SPID_03_2025 Large Demand Customers FRT Modification

Grid Code Modification Report

27 April 2026

Figure CC.14.1.6: Voltage-against-time profile at the connection point for fault condition

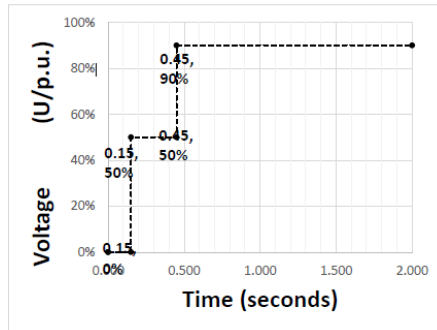
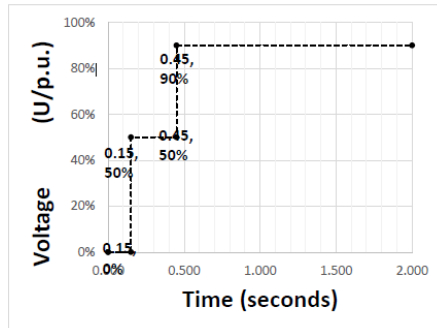
Clause	Red Line Version Text
CC.14.1.5	<p>Deleted text in strike through red font and new text highlighted in blue font</p> <p>Demand Facilities shall remain connected to the Transmission System during rate of change of Transmission System Frequency of values up to and including 1Hz per second as measured over a rolling 500 milliseconds period. (Voltage dips may cause localised RoCoF values in excess of 1 Hz per second for short periods, and in these cases, the Fault-Ride Through clause CC.14.1.6 supersedes this clause (CC.14.1.5))</p>
CC.14.1.6	<p>Demand Facilities shall remain connected to the Transmission System during and following any Fault Disturbance on the Power System which results in a Voltage deviation which remains on or above the voltage-against-time profile specified in Figure CC.14.1.6 at the Connection Point. Following clearance of the Fault Disturbance, the Demand Facility should return to at least 90% of its prefault Active Power Demand within 500 milliseconds of the Transmission System Voltage recovering to 90% of the nominal Voltage. The post Fault Disturbance ramp up rate for the Demand Facility, shall be coordinated and agreed between the TSO and the Demand Facility owner. The voltage-against-time profile specifies the required minimum capability as a function of voltage and Fault Ride-Through Time at the Connection Point before, during and after the Fault Disturbance.</p>

Demand Facilities shall remain connected to the **Transmission System** during and following any **Fault Disturbance** on the **Power System** which results in a **Voltage** deviation which remains on or above the voltage-against-time profile specified in Figure CC.14.1.6 at the **Connection Point**. Following clearance of the **Fault Disturbance**, the **Demand Facility** should return to at least 90% of its pre-fault **Active Power Demand** within 500 milliseconds of the **Transmission System Voltage** recovering to 90% of the nominal **Voltage**. The post **Fault Disturbance** ramp up rate for the **Demand Facility**, shall be coordinated and agreed between the **TSO** and the **Demand Facility** owner. The voltage-against-time profile specifies the required minimum capability as a function of voltage and **Fault Ride-Through Time** at the **Connection Point** before, during and after the **Fault Disturbance**.
